STAFF REPORT

NEW BEDFORD HISTORICAL COMMISSION MEETING

CASE # 2018.31: CERTIFICATE OF APPROPRIATENESS

72 N Water Street (Map 53 Lot 68)

1 GROUND FLOOR PLAN - PROPOSED ADDITION
SCALE: 3/16" = 1'-0"

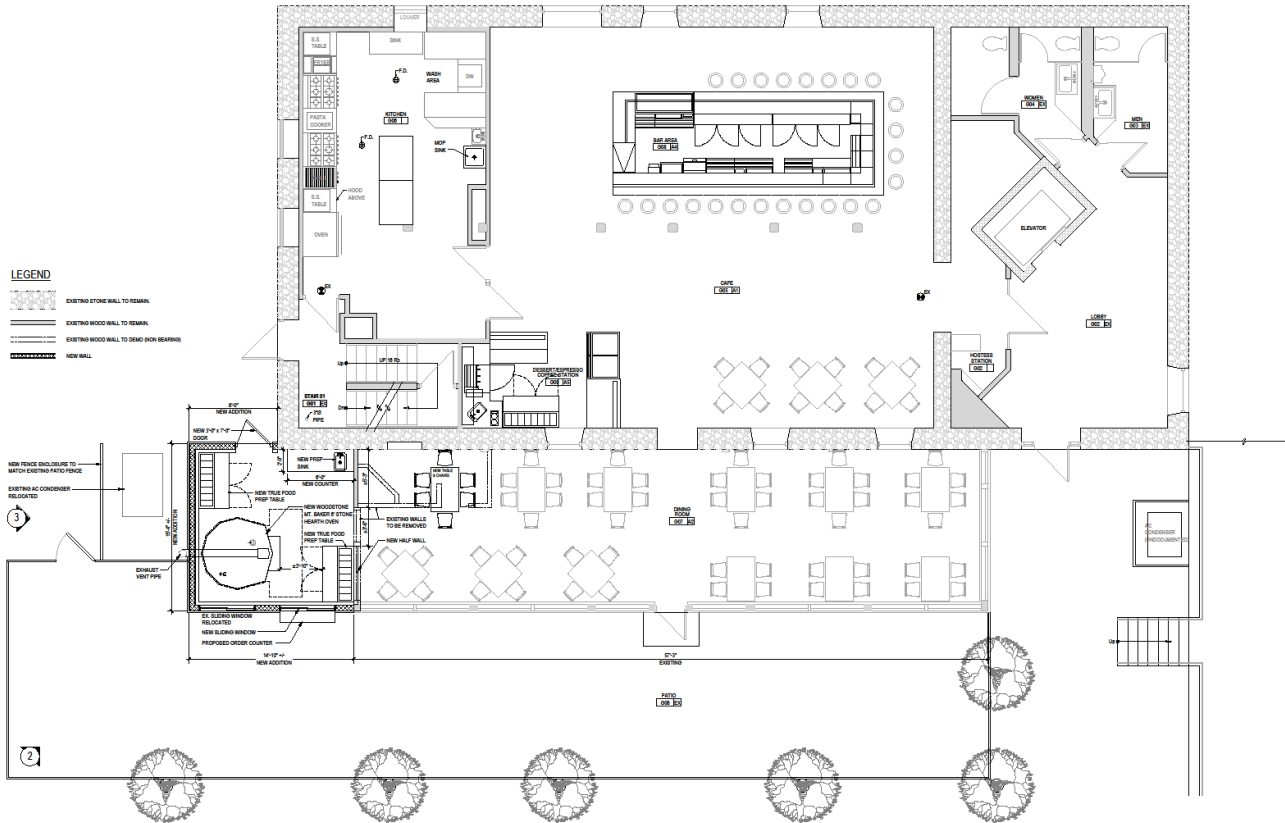
In consideration for the Hamilton Street viewshed, Staff recommends additional fence screening for the air condenser than what is proposed. The height of the hearth oven vent is not specified and should be provided. The window counter material is not specified, and should be of a material that is weather proof yet compatible with the site. The exterior door type and south façade details are not specified and should be provided.

Staff recommends the approval of the application and the granting of a Certificate of Appropriateness with the condition that additional screening is provided, that all visible venting and ductwork be black, and all new building materials match the existing.
